Memo

To: Jonathan Page, NCSU
From: Jeff Walton, Associate Planner; 910-341-3260
CC: File;
Date: 10/21/2015
Re: Dreams Parking Lot

Site Plan Comments:

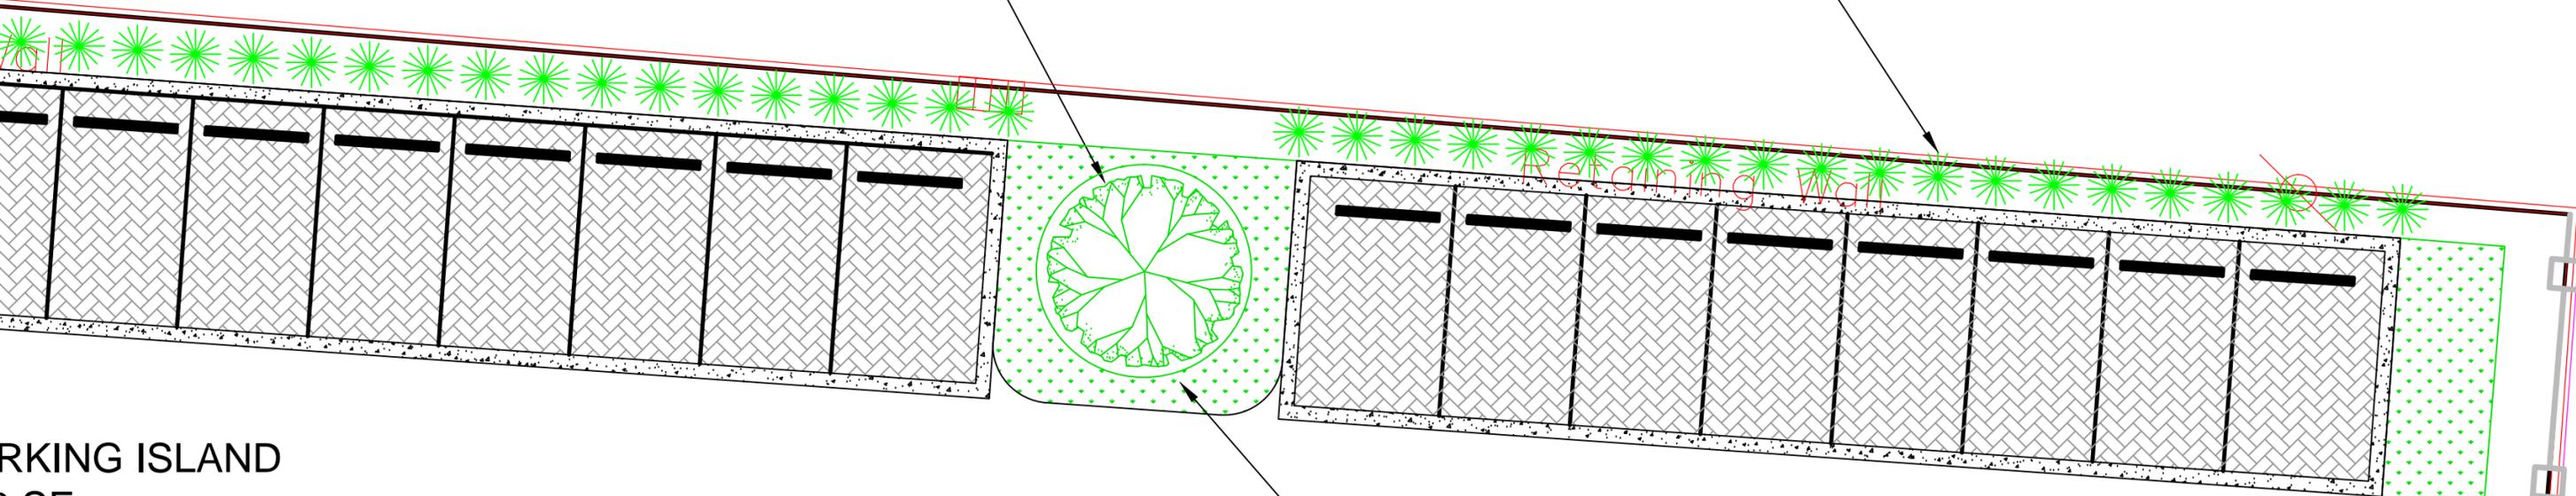
- Each parking lot island must be a minimum of 216 SF, please label each island. I have a redline attached to explain.

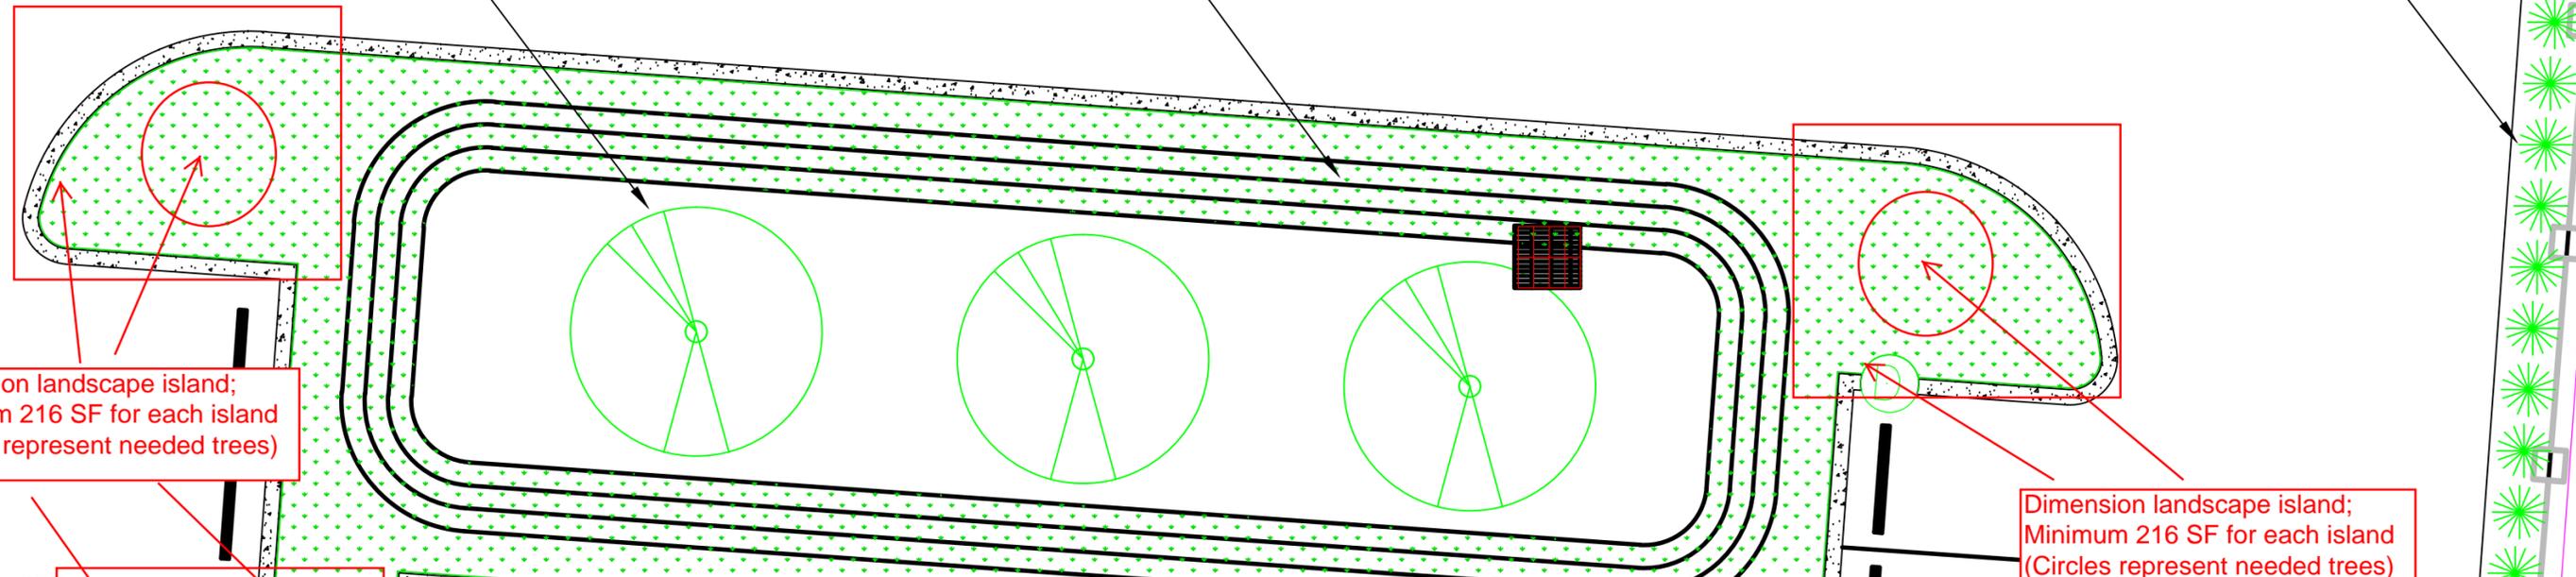
Dimension landscape island;
Minimum 216 SF for each island
(Circles represent needed trees)

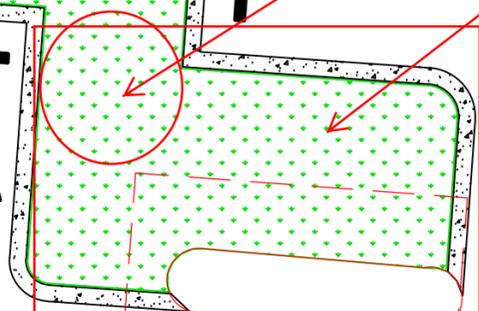
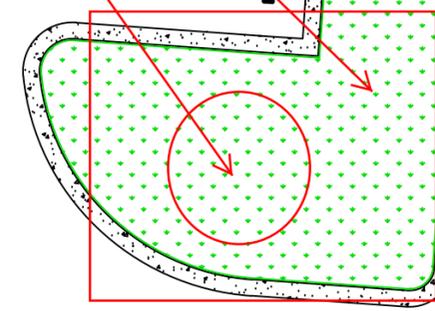
Dimension landscape island;
Minimum 216 SF for each island
(Circles represent needed trees)
